**ADDENDUM TO
ENVIRONMENTAL IMPACT REPORT**

LION'S GATE RESERVE

LEAD AGENCY: COUNTY OF SANTA CLARA

**File #4039-67-28-93
SCH #94043016**

FIGURE 13a

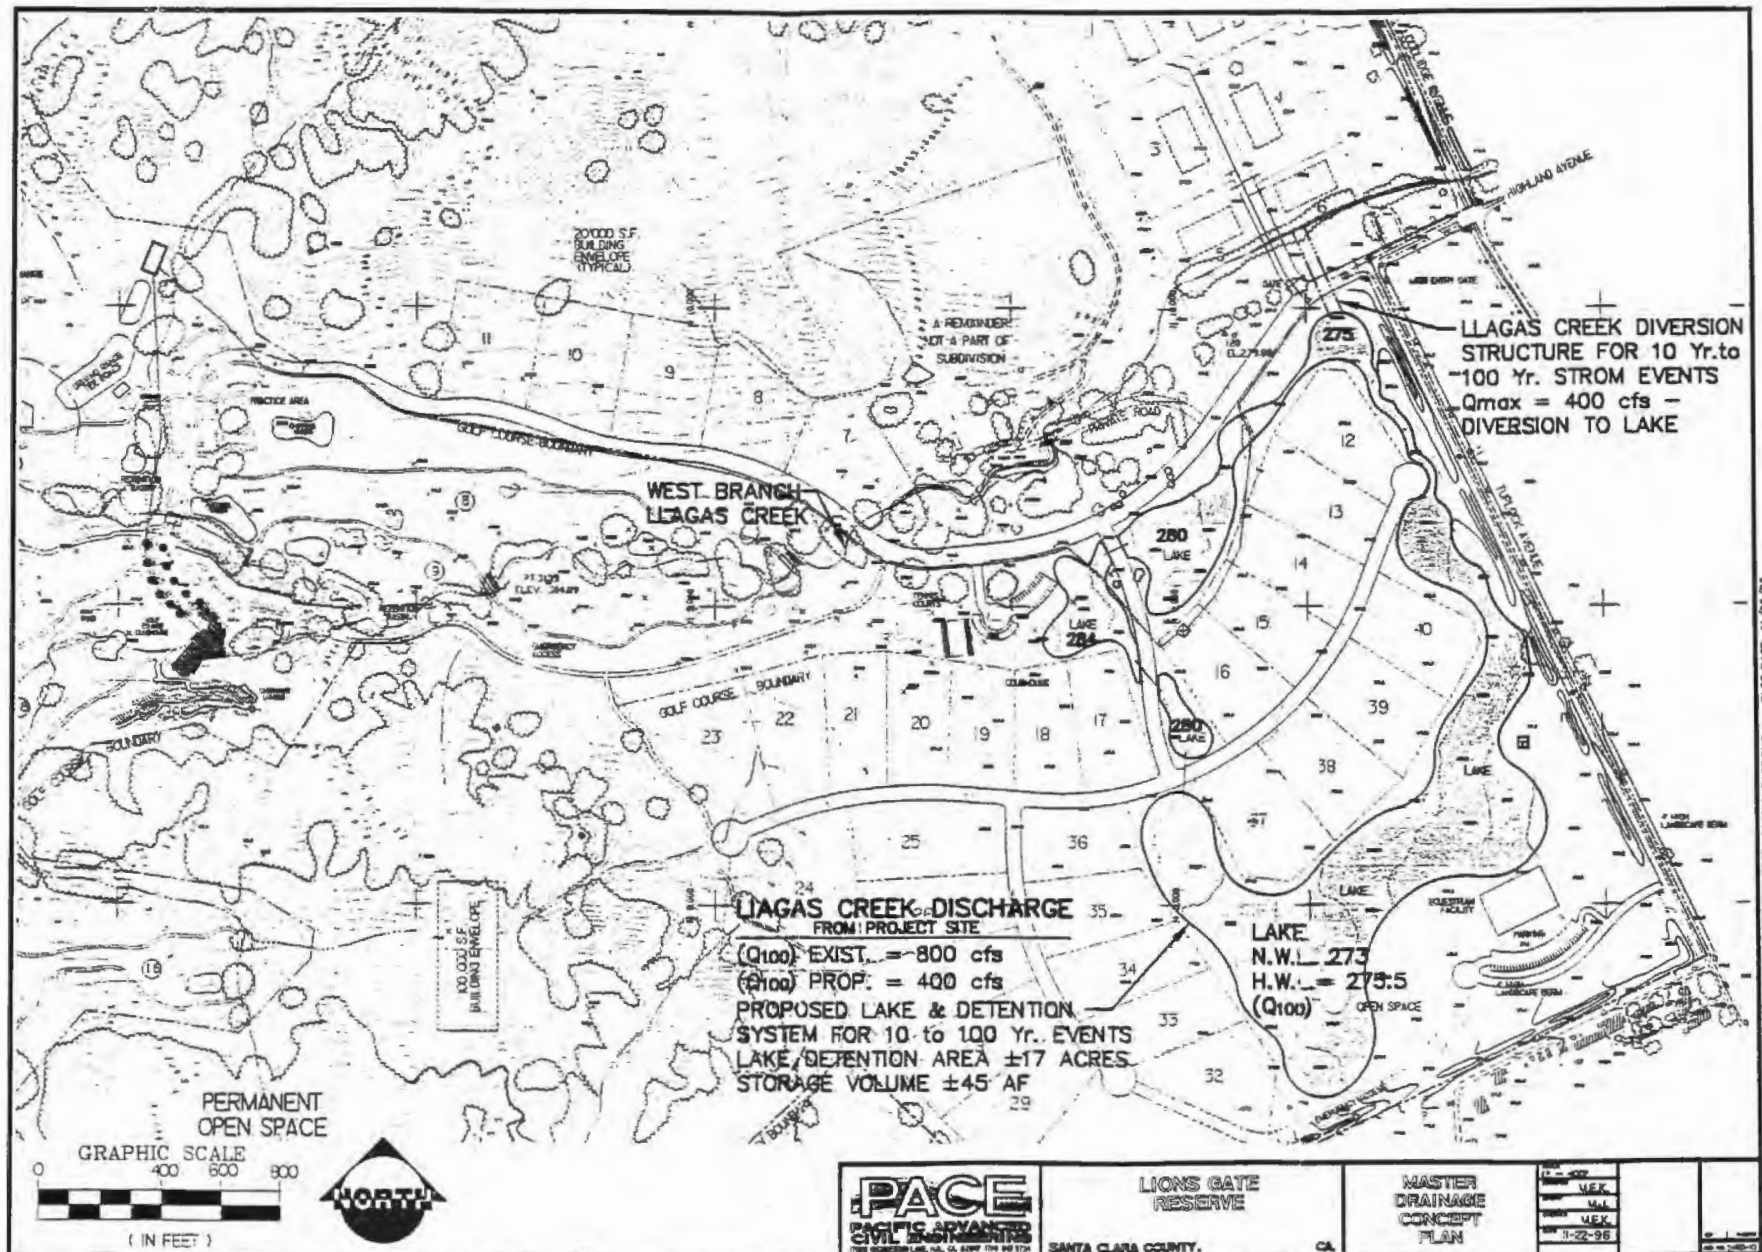
The on-site lake proposed for the southern residential cluster subdivision would be designed to provide sufficient detention storage for increased peak runoff resulting from site development. In addition, a diversion structure would be constructed in the creek channel to divert a substantial portion of storm flows exceeding existing 10-year flow rates to the residential lake, which would be sized to accommodate about one-half of the flows from the 100-year event. ~~With this pond~~ With these facilities, the peak flow rates leaving the project site during the 100-year and 10-year storms significant storm events would be substantially lower than under existing conditions.

The potential increased runoff from the residential area during the 100-year event would be 65 cubic feet per second, without the proposed lake. The proposed lake would have a normal water surface elevation less than the top of bank elevation of West Branch Llagas Creek at the outfall from the pond. ~~The outfall would have a flap gate to prevent high water levels in the creek from discharging back into the pond.~~ The diversion structure in the creek would be designed such that a substantial portion of the flows in the creek less than the existing 10-year peak flow would pass under the structure and would not be able to enter the side channel to the lake. Flows exceeding the 10-year peak flow would be blocked by the structure and diverted to the lake for temporary storage (see Figure 13a). This would reduce the 100-year flow rate leaving the site from approximately 800 cfs under existing conditions to approximately 400 cfs. This substantial reduction in flood flows leaving the site would significantly reduce flooding problems along the West Branch of Llagas Creek downstream of the site. However, there still would be overland and downstream flooding during the 100-year event, but the extent and volume of flooding would be reduced as a result of the proposed diversion and storage. Once the storage capacity of the lake is reached, any additional flows would be prevented from entering the lake. Instead, these extreme flood flows would be allowed to overspill the creek, as would

occur under existing conditions. The outflow from the pond lake would only occur when the water level in the creek is low. Therefore, the outflow from the pond would not contribute to the existing flood problems from the creek channel.

FIGURE 23a

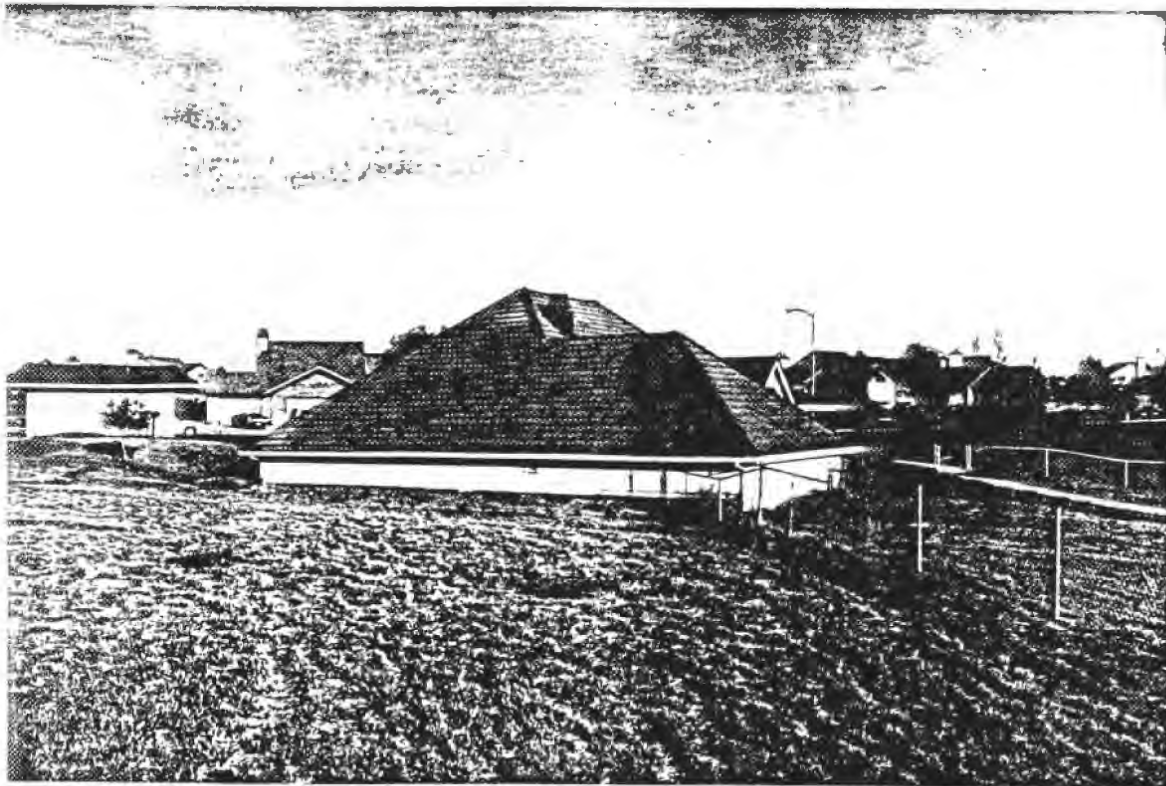
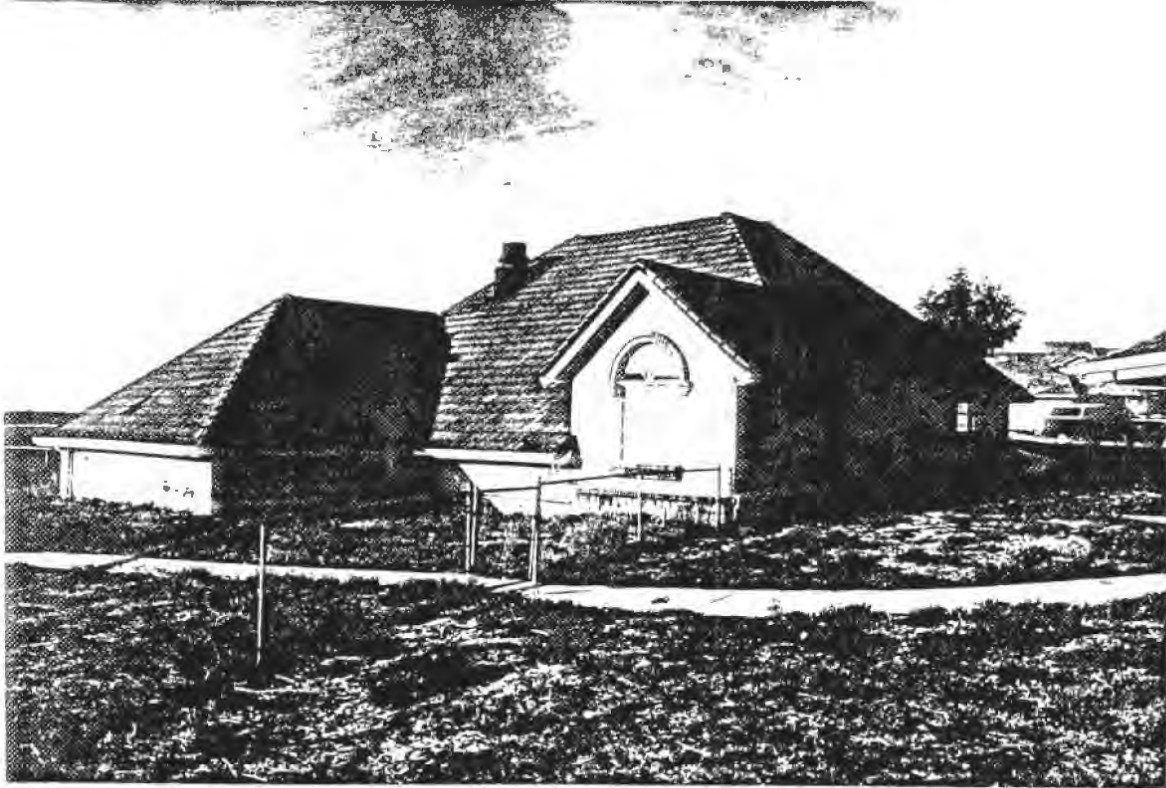
As mentioned, the treatment plant would be located near the southeast corner of the site to take advantage of gravity flow and reduce pumping requirements. The entire treatment facility, including disinfection tanks, sludge ponds, and controls, would be housed in a one-story building with a low-profile barn-like or residential appearance. The treatment facility would occupy an area measuring 40 feet by 40 feet, and the adjacent constructed wetland would be approximately .75 acres in area (see Figure 2 in the report by Pacific Advanced Civil Engineering, contained in Appendix N). An SBR treatment plant similar to the one proposed has been in operation at the Cielo Vista Estates project in Hollister since 1989. That facility currently serves 76 residences and treats approximately 50,000 gallons of wastewater daily, about double the volume of the proposed treatment facility for the Lion's Gate project. That facility appears as a dwelling located within a residential neighborhood, with the nearest house located 100 feet away. Photographs of this facility are provided in Figure 23a.

Long-term Wet Weather Storage: Long-term (120-day) storage of treated wastewater during the wet season would be provided by a dedicated effluent storage pond to be excavated to the west of the treatment plant. The pond would appear as part of the residential lakes proposed for this area, but in fact would be a separate impoundment. The pond would have a capacity of 6.4 acre-feet and would occupy 1.75 acres. The pond would be lined with either clay or PVC depending on soil suitability; the liner would be backfilled with a minimum of 18 inches of soil and landscaped to blend in with the surrounding area.

FIGURE 1

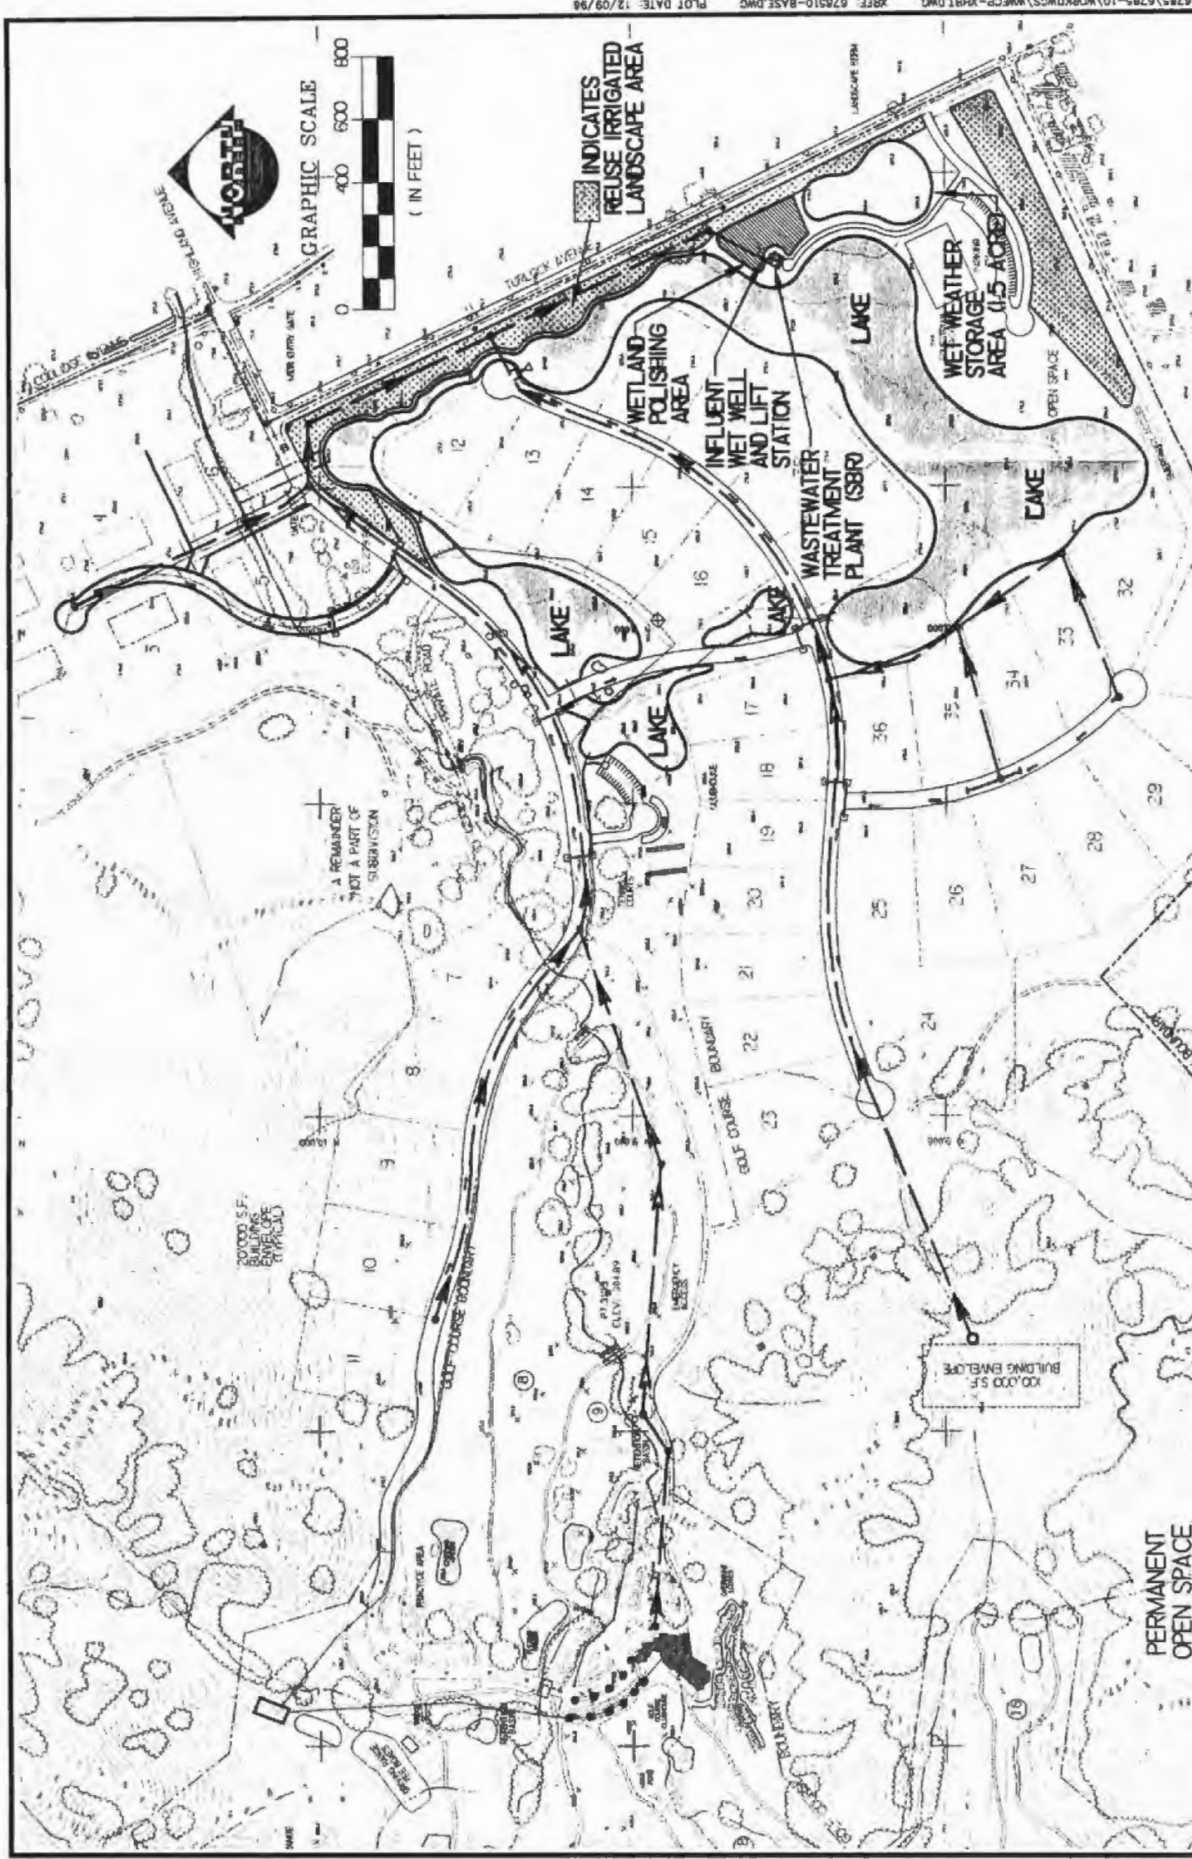
The entire project can be sewerred by gravity flow of all sewage (not just effluent as previously proposed) to an advanced treatment plant (see attached Figure 1). The sewer collection system will pass through a grit screen and empty into a wet well at the treatment plant. Lift pumps will be used to lift the influent to the SBR tank. The proposed treatment method will utilize the Sequential Batch Reactor (SBR) process, combined with disinfection and final (tertiary) treatment occurring at a constructed wetland area. Discharge of treated effluent will pass from the SBR tank, through a disinfection tank, and flow by gravity out of the disinfection tank through the wetlands polishing cells (please refer to Figure 2). As an alternative to the wetlands polishing system, a rapid sand filtration system will be considered. Finally, treated (oxidized, clarified, disinfected, and polished) effluent will be pumped from the wetlands for use in project landscape buffer irrigation. A storage basin will be provided near the irrigation facilities for storage of reuse water during winter wet weather periods when irrigation reuse is not acceptable.

FIGURE 9b

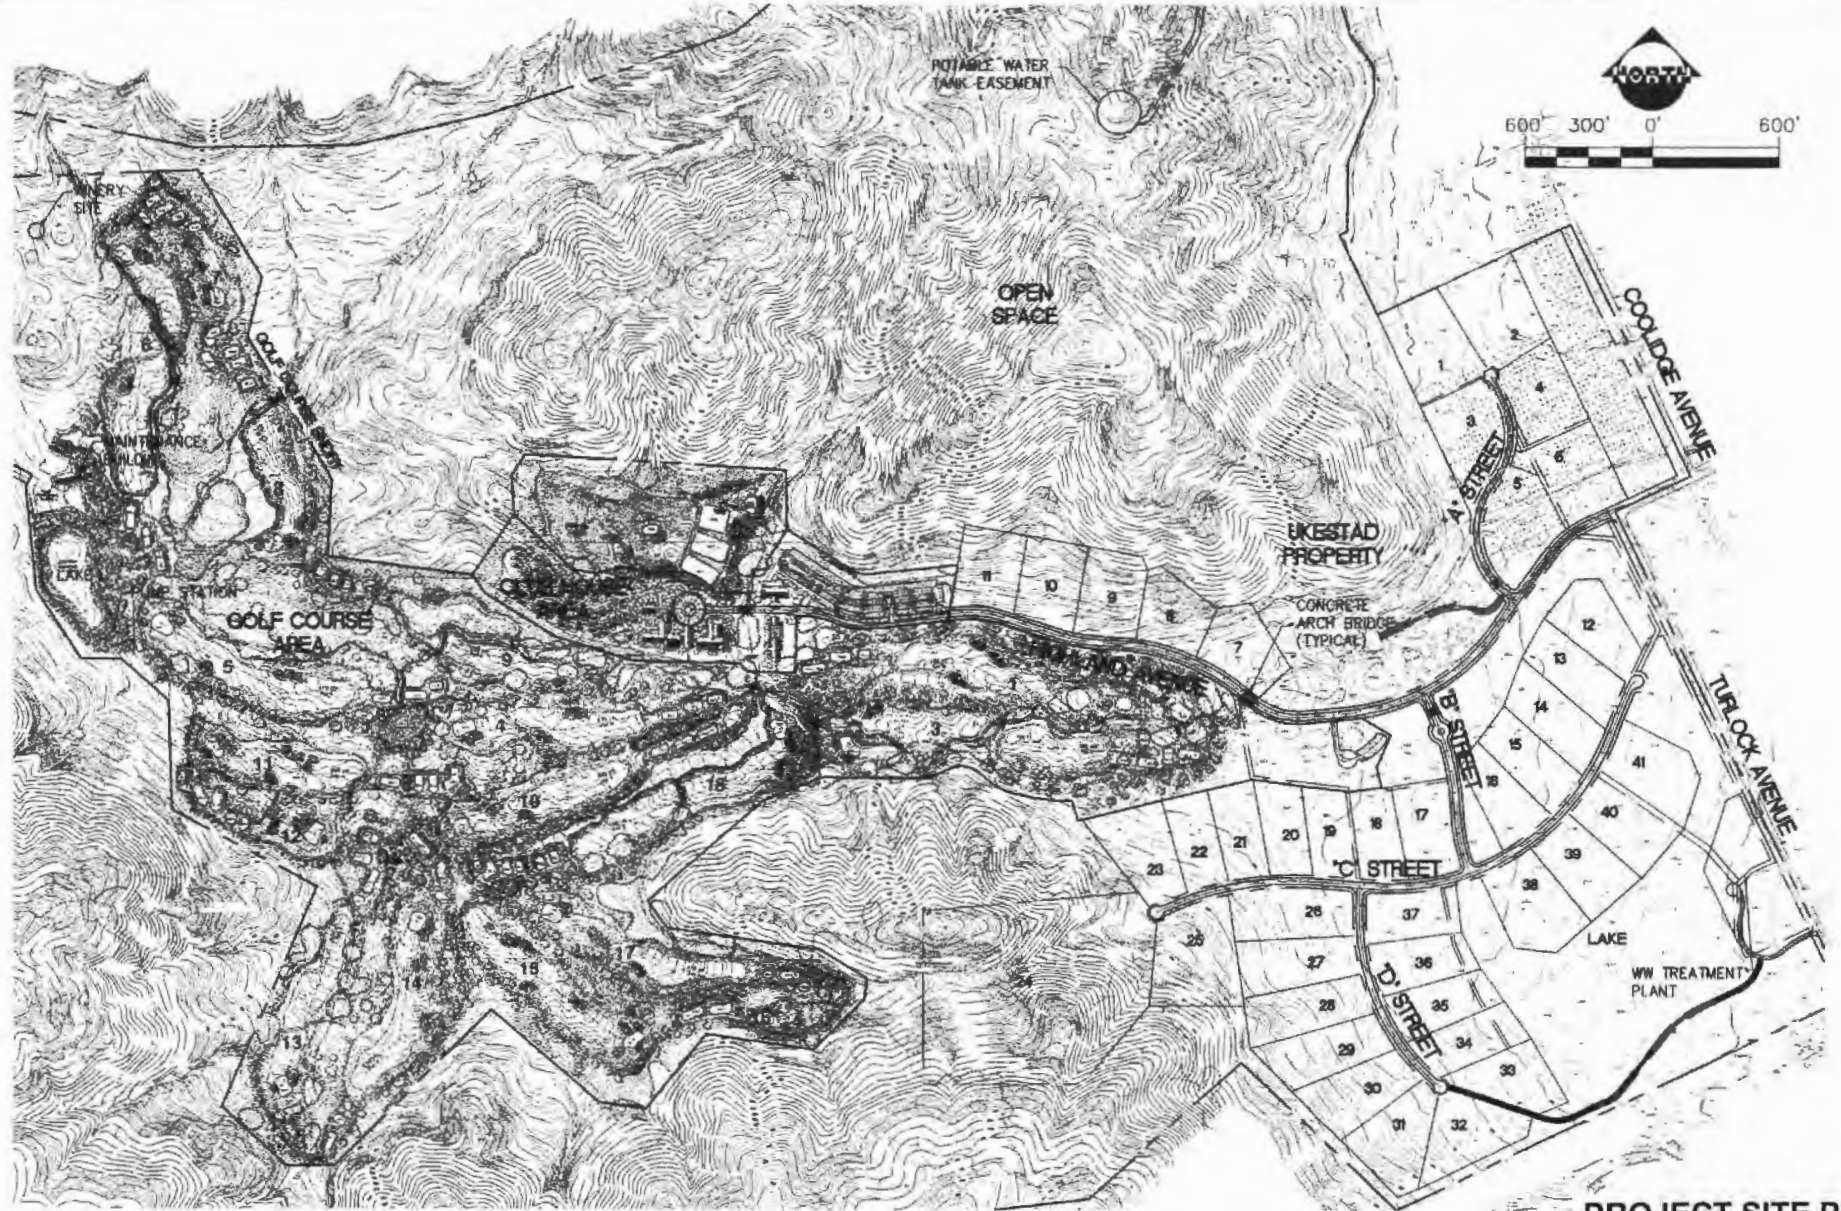
The new clubhouse location is preferred by the applicant because it provides more land area for the facilities, thus allowing for a less intense building pattern. The new site has better sun exposure with its southward orientation, and it also offers better views of the golf course and Lion's Peak, as well as better protection from the wind. The new clubhouse/overnight complex site is located to the south of a series of low ridges and hills where it is completely screened from view from off-site locations. The new site avoids the use of retaining walls, and also avoids the landslide on the adjacent hillside to the south, which required a geotechnical engineering solution for the previous clubhouse location. The clubhouse/overnight complex will be sited a minimum of 75 feet from the main creek channel and the tributary channel to the east. The new location allows the parking area to be consolidated into a single location north of the main access road, and allows siting of the parking area closer to the clubhouse area. The new parking lot location is several hundred feet from the main creek channel and 75 feet from a tributary channel at its nearest edge. No tree removal is required at the new clubhouse location.

The proposed location of the complex on the north side of the creek also eliminates the need for a vehicle bridge across the creek, as well as crossings by sanitary sewer and utility lines. The County Fire Marshal's office has indicated that the new location and configuration for the clubhouse/overnight complex is preferable to the previous plan because the shorter length of the access road would improve response times, the less steep slope of the fire access route to the overnight units improves accessibility, and the generally better accessibility of single-story structures compared to multi-story buildings proposed previously.
